# Jetter

Technical Information  
Version Update

**June 25 2002**

**JX6-CON1 / JX6-CON+ Changes  
Version 2.801 through Version 3.000**

### 1.1 Axis Control

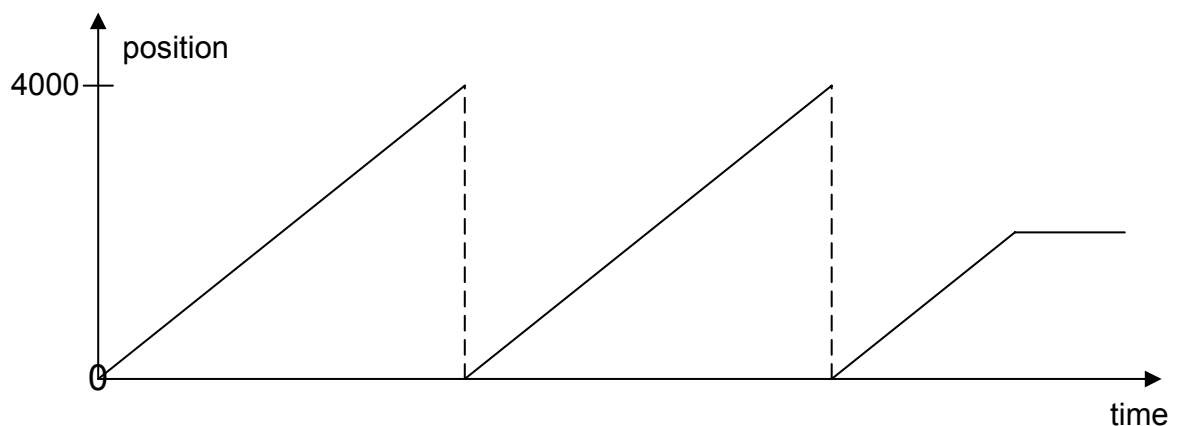
- (2.804) The overflow mode can be activated by command 16:  
In this mode, the overflow register (1xy085) is taken into account for a positioning process and the actual position is set to zero if necessary. The set positions are given as absolute values. The mode is disabled by command 18.
